Municipal Planning Commission AGENDA

Monday, February 3, 2025 — 6:30 p.m. Bartlett City Hall Assembly Chamber

Monday, February 3, 2025 - 6:30 P.M. Bartlett City Hall Assembly Chamber Staff Comments

1. Union Depot Phase 3, 6896 Highway 70 (Roy Lamica, EFI Global)

SCALE NTS SHEET 1 of 1 CITY OF BARTLETT DIVISION OF ENGINEERING SEWER PROFILE AND DETAILS LOCATION: SUMMER AVENUE BARTLETT, TENNESSEE DESIGN BY: ____EFI GLOBAL DATE __01.06.25_ SCALE AS NOTED

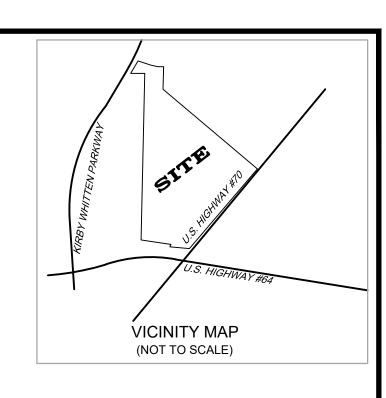
- 21) Indicate on profile that 8" sewer pipe is to be SDR-26.
- 22) Detail 2 is a City of Memphis detail. Although acceptable to use, the City of Bartlett will require steps in the manhole.
- 23) Add the City of Bartlett detail for a typical sewer cleanout.

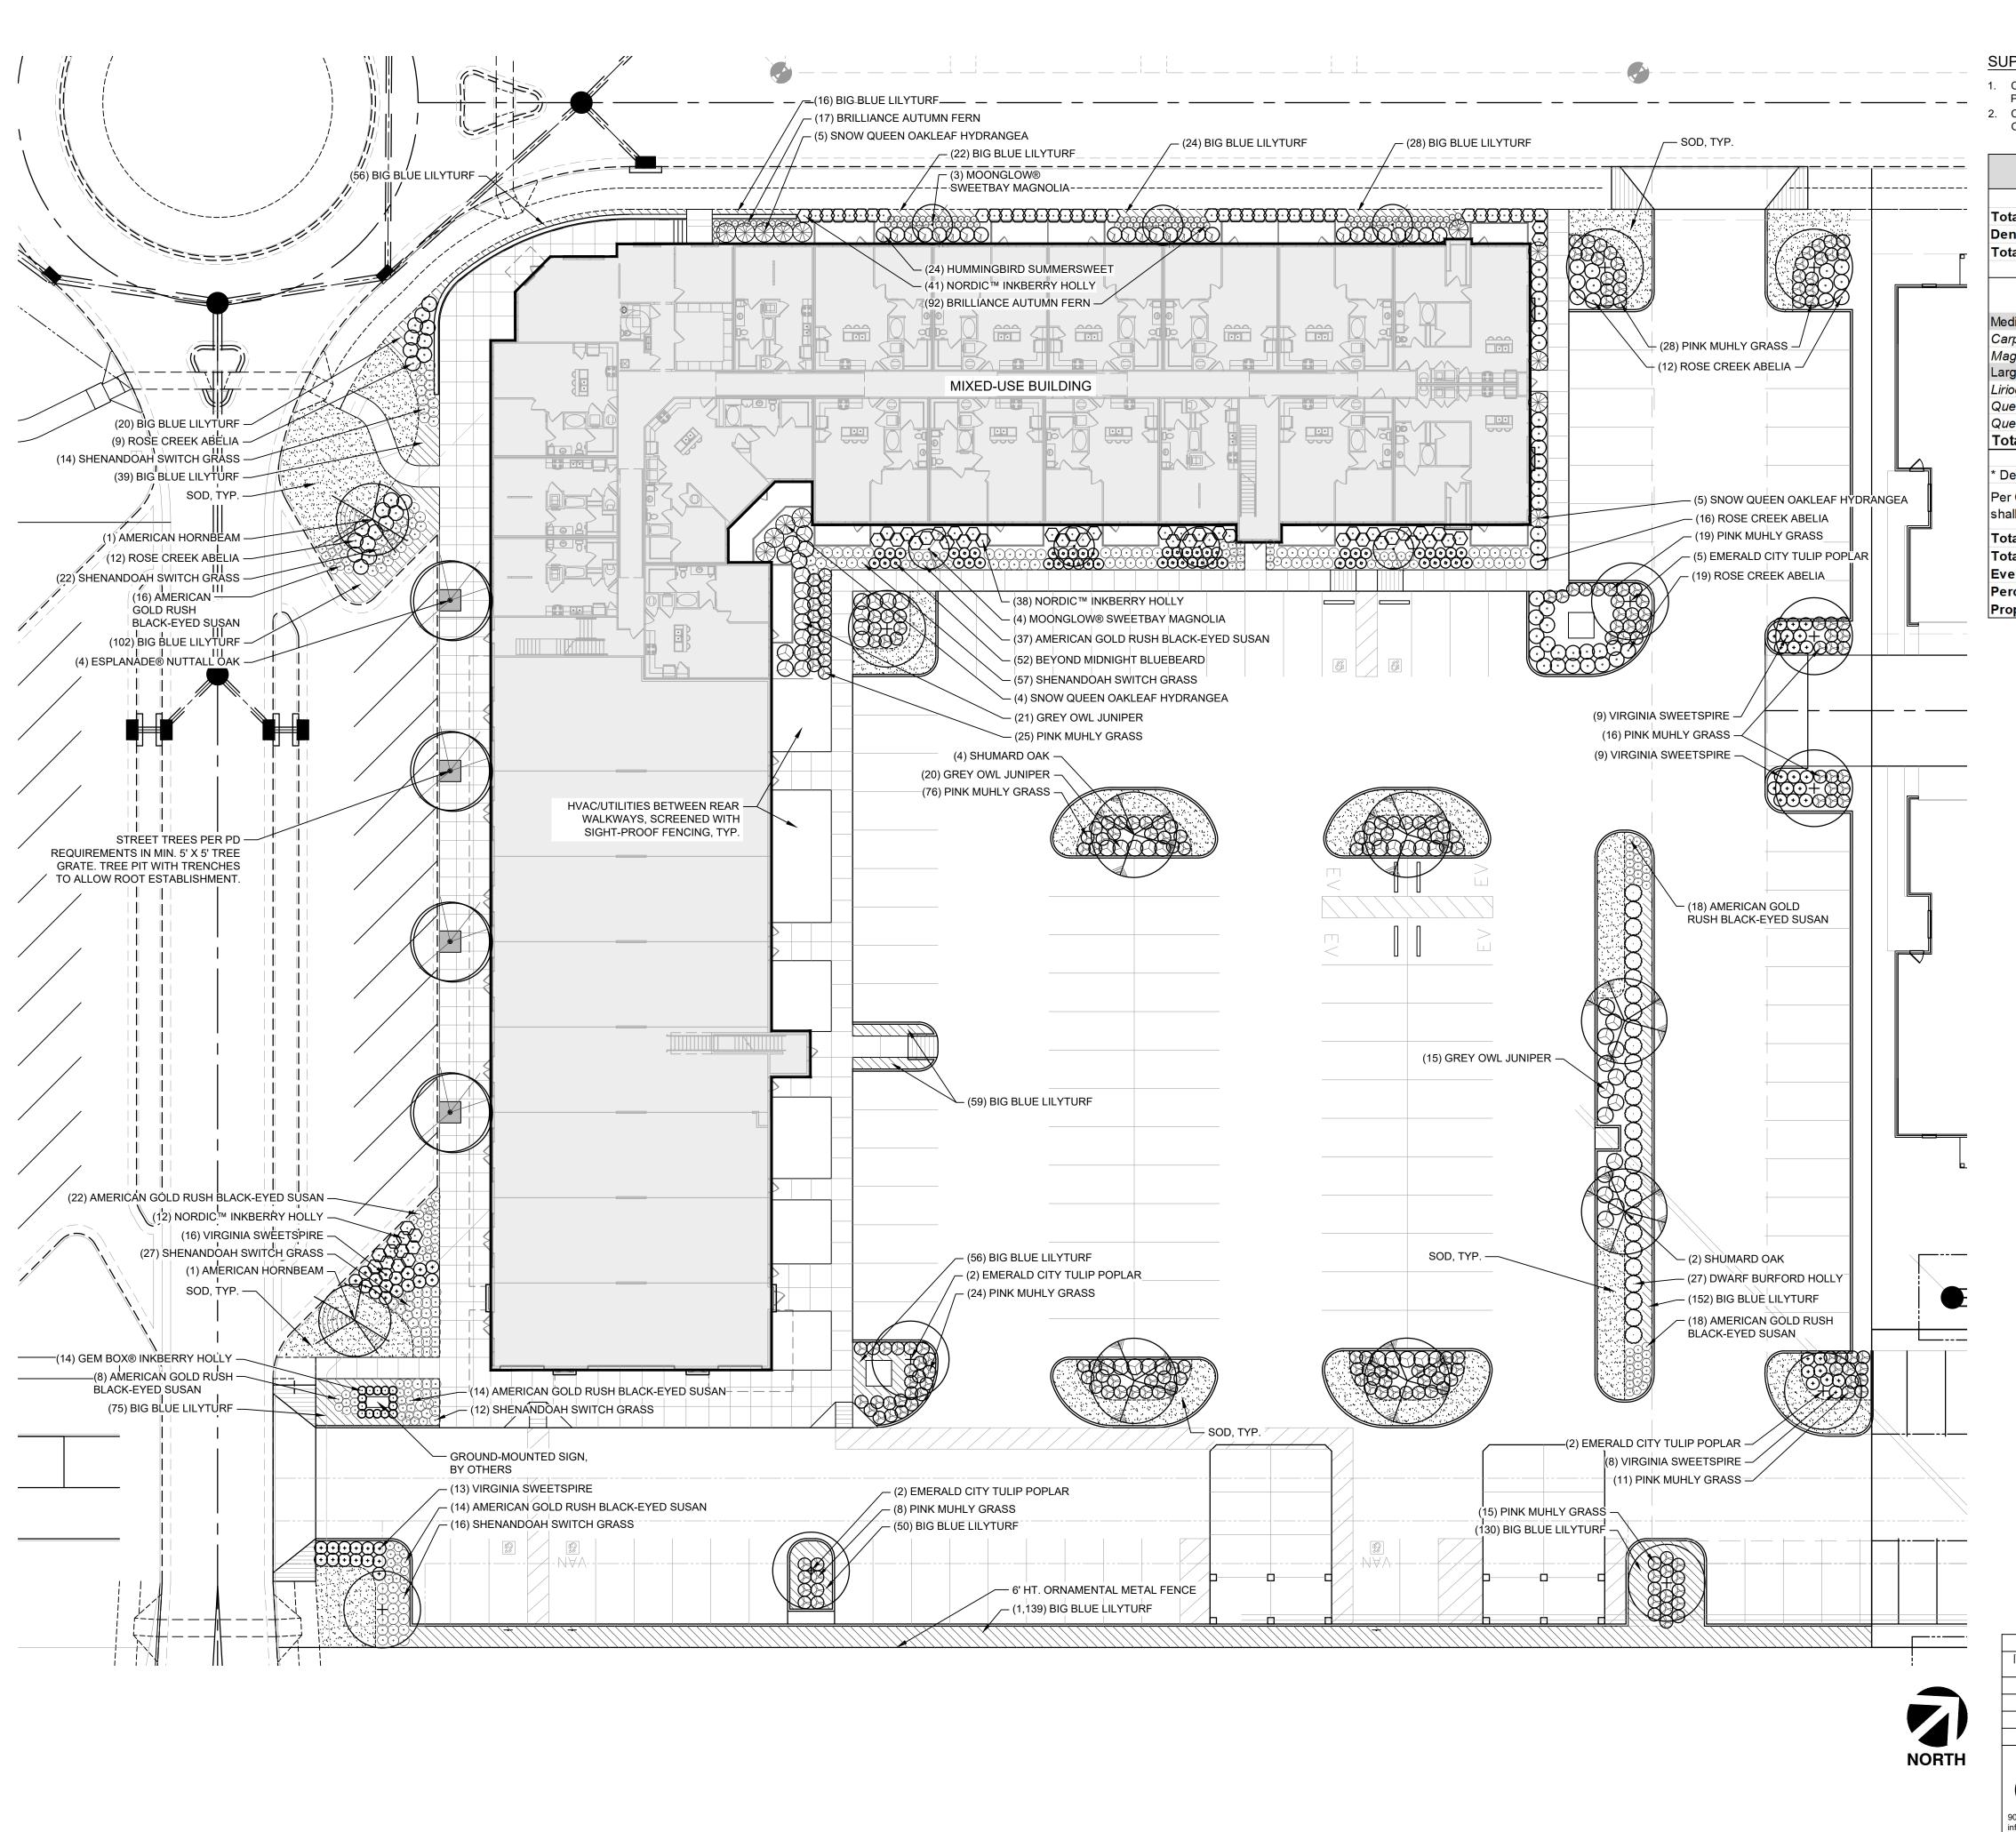
- 7) Subdivision monument locations shall be shown in accordance with the subdivision regulation.
- 8) Drainage easement extension shall be shown.
- 9) First note on plat sheet 1 needs to include drainage for utility maintenance.

SCALE NTS SHEET 1 of 1 CITY OF BARTLETT DIVISION OF ENGINEERING SEWER PROFILE AND DETAILS LOCATION: SUMMER AVENUE BARTLETT, TENNESSEE DESIGN BY: ____EFI_GLOBAL DATE __01.06.25_ SCALE AS NOTED

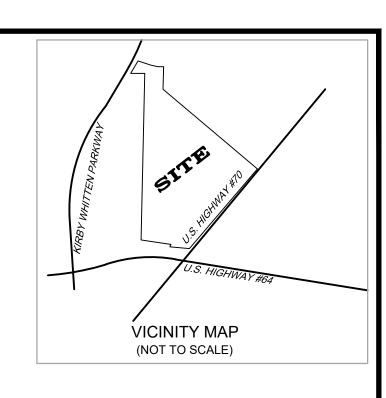
- 21) Indicate on profile that 8" sewer pipe is to be SDR-26.
- 22) Detail 2 is a City of Memphis detail. Although acceptable to use, the City of Bartlett will require steps in the manhole.
- 23) Add the City of Bartlett detail for a typical sewer cleanout.
